Addendum No. 2

Project: Fort Wayne International Airport
Construct Taxiway G Extension & Demolish Taxiway C2
AIP No. 3-18-0022-XX

Date: June 20, 2024

Drawing No.: **E2.1.1**

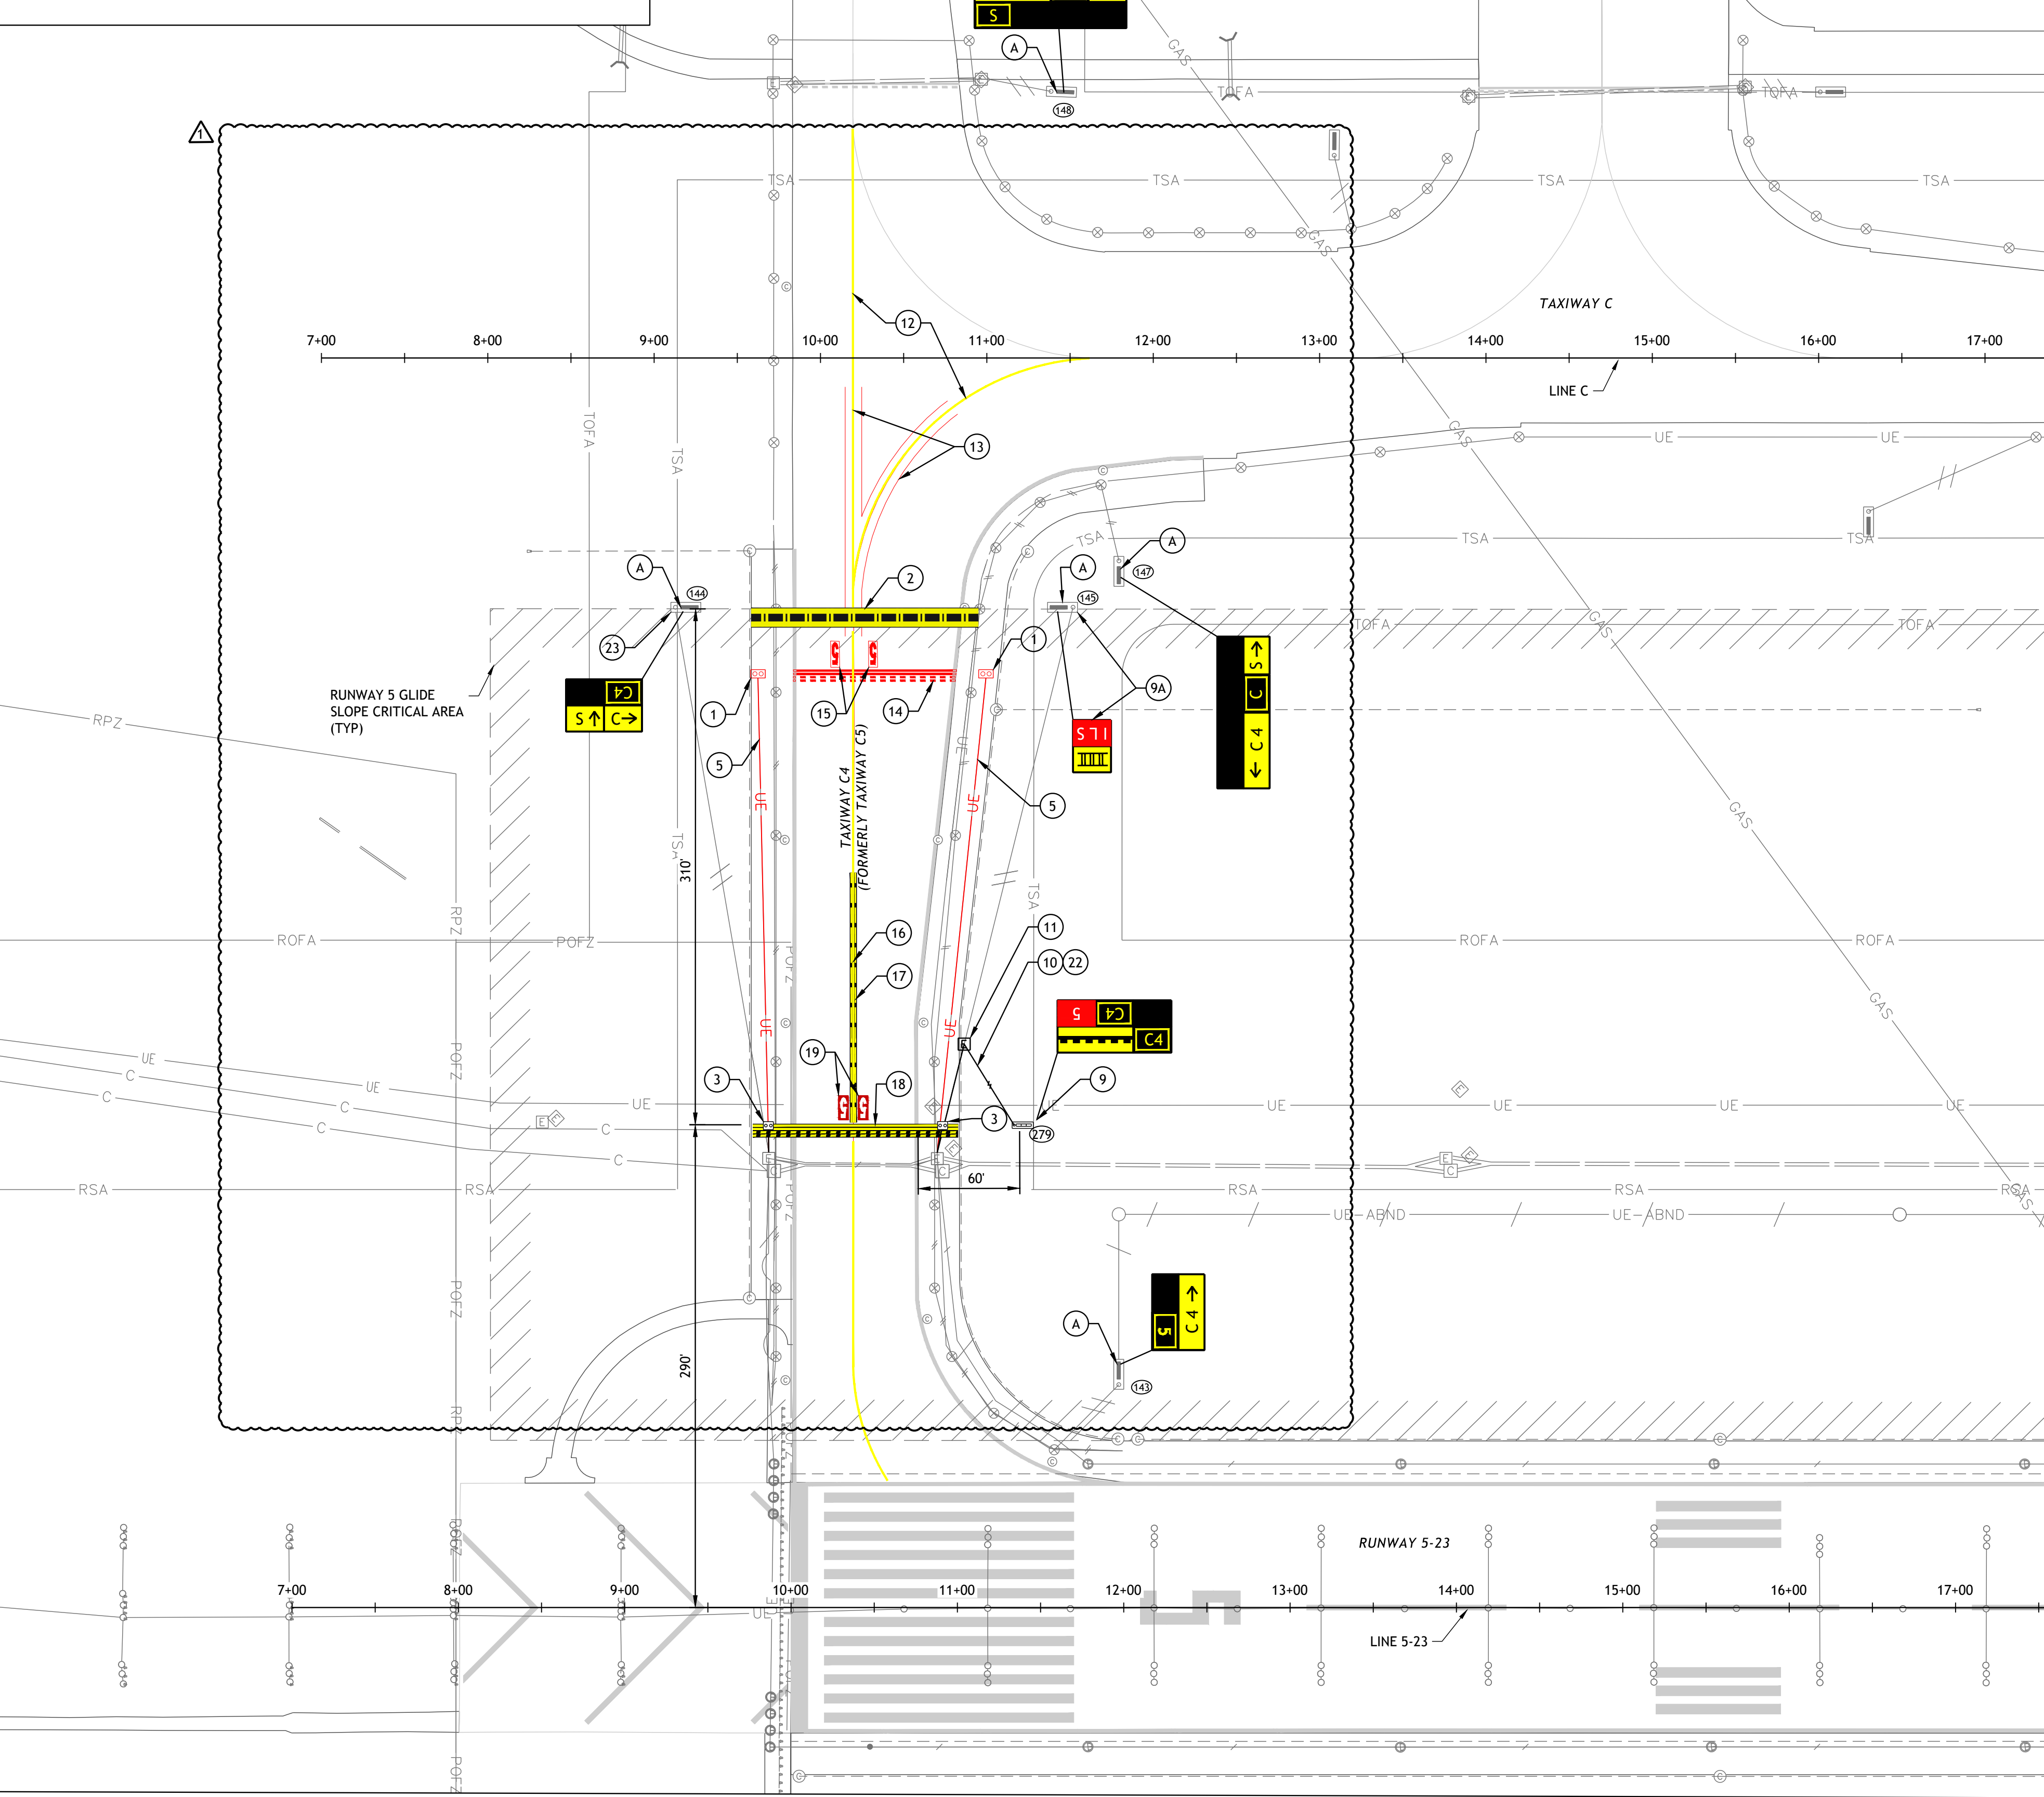
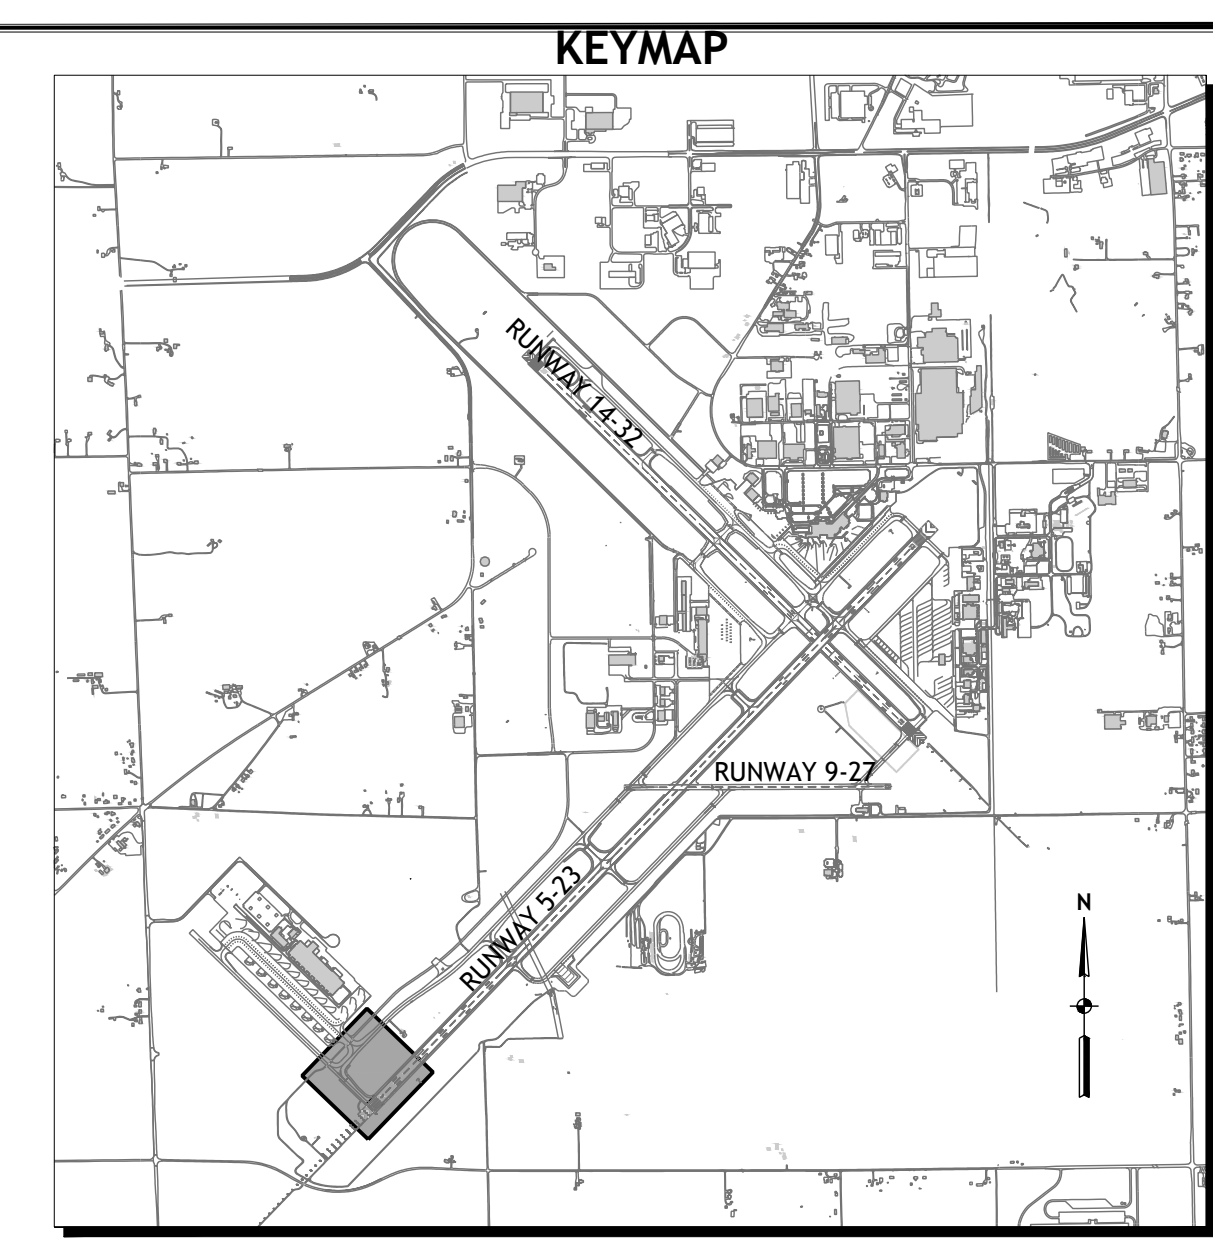
Reissued: Plan sheet reissued to reflect installation of new hold position location, and conversion of former hold position location to instrument landing system (ILS) hold position.
